CITY OF ALBUQUERQUE

**RE: The Varela Residence Volcano Cliffs Unit 18
6505 Pato Rd NW, S.A.D. 228, Lot 21 Block 6
Grading and Drainage Plan Date 12/27/16 (D10D003M21)
Pad Certification Date 1/25/17
CO Approval Date 6/2/2020
Revised G&D plan for pool Date: 3/20/2023**

DRAINAGE AND TRANSPORTATION INFORMATION SHEET (REV 11/2018)

C-1.0

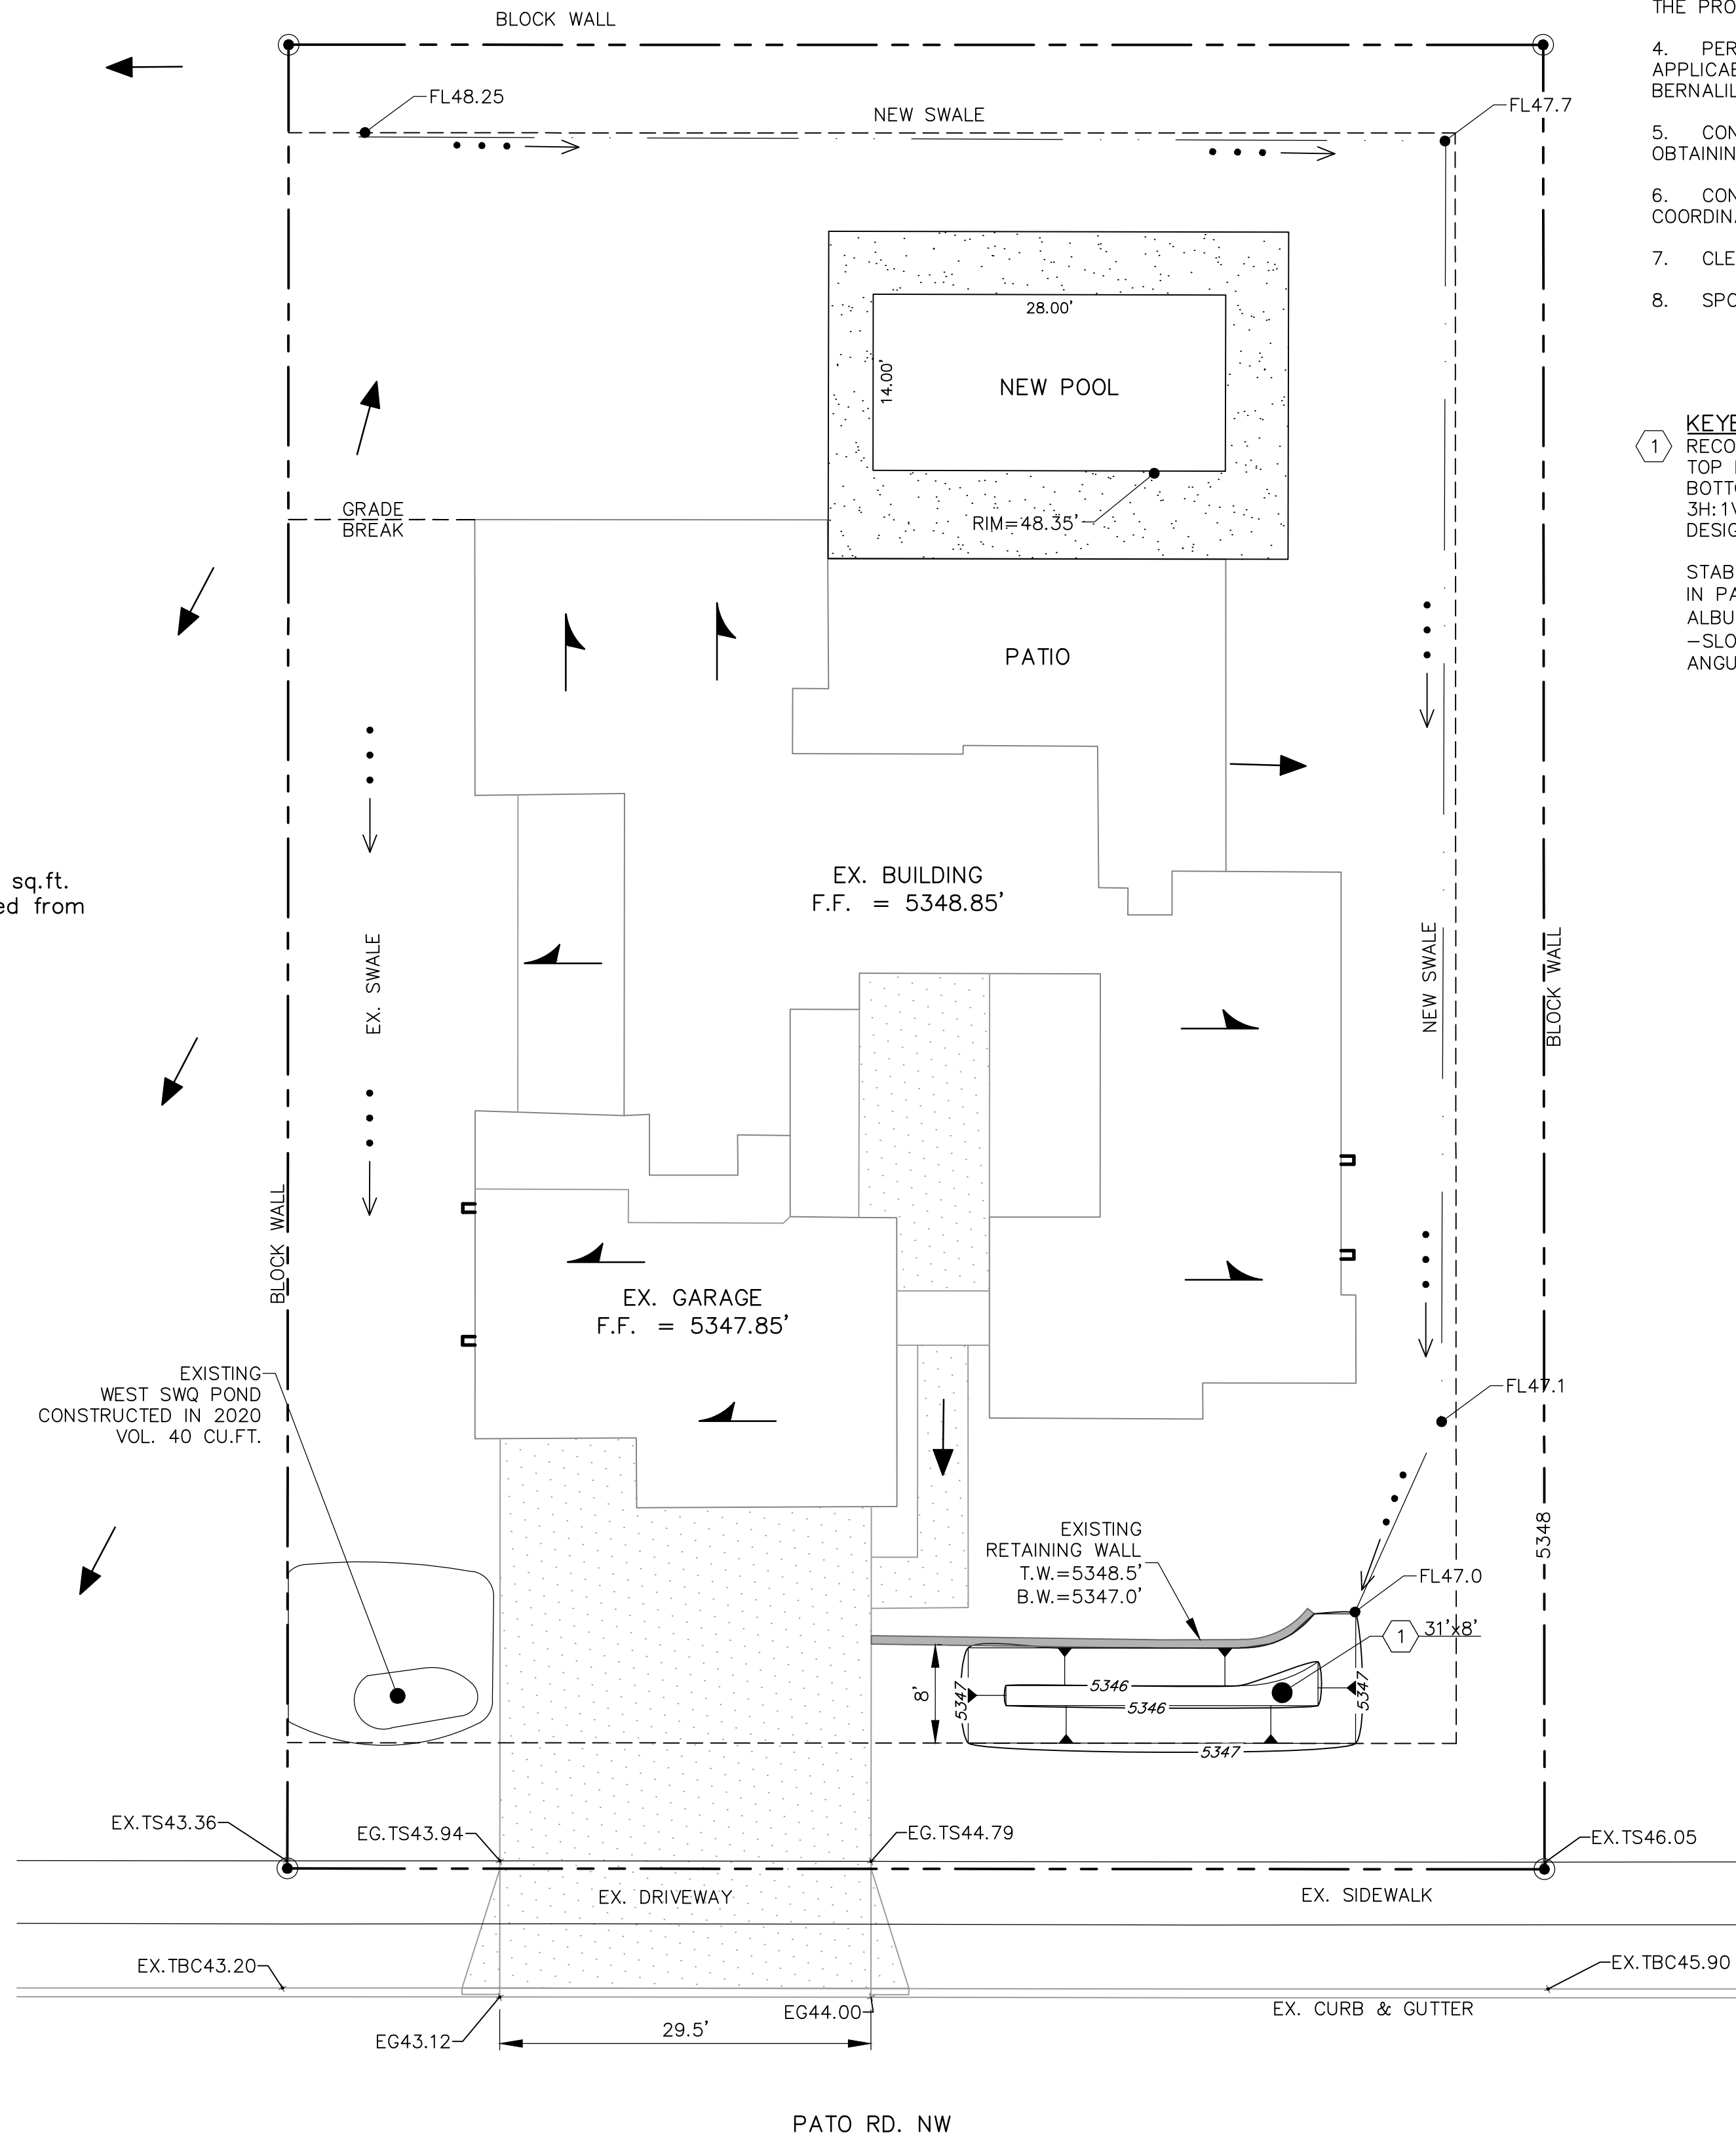
Based upon the information provided in your submittal received 3/24/2023, this plan is approved for a revised Grading Permit, and will now be the plan of record.

Prior to Building permit approval a Pad Certification will be required, provided by the Engineer or a registered Land Surveyor.

Advise the owner contractor not to use dirt as a ramp to climb the curb, use lumber or crusher fines for this purpose.

Reiterate to the Owner/Contractor that a separate permit for a garden/retaining wall must be obtained with the approved G&D plan and Pad Certification. Also, if a swimming pool is to be placed the grading and drainage plan will change and will need to be resubmitted.

Prior to Certificate of Occupancy release, Engineer Certification per the DPM checklist is required.
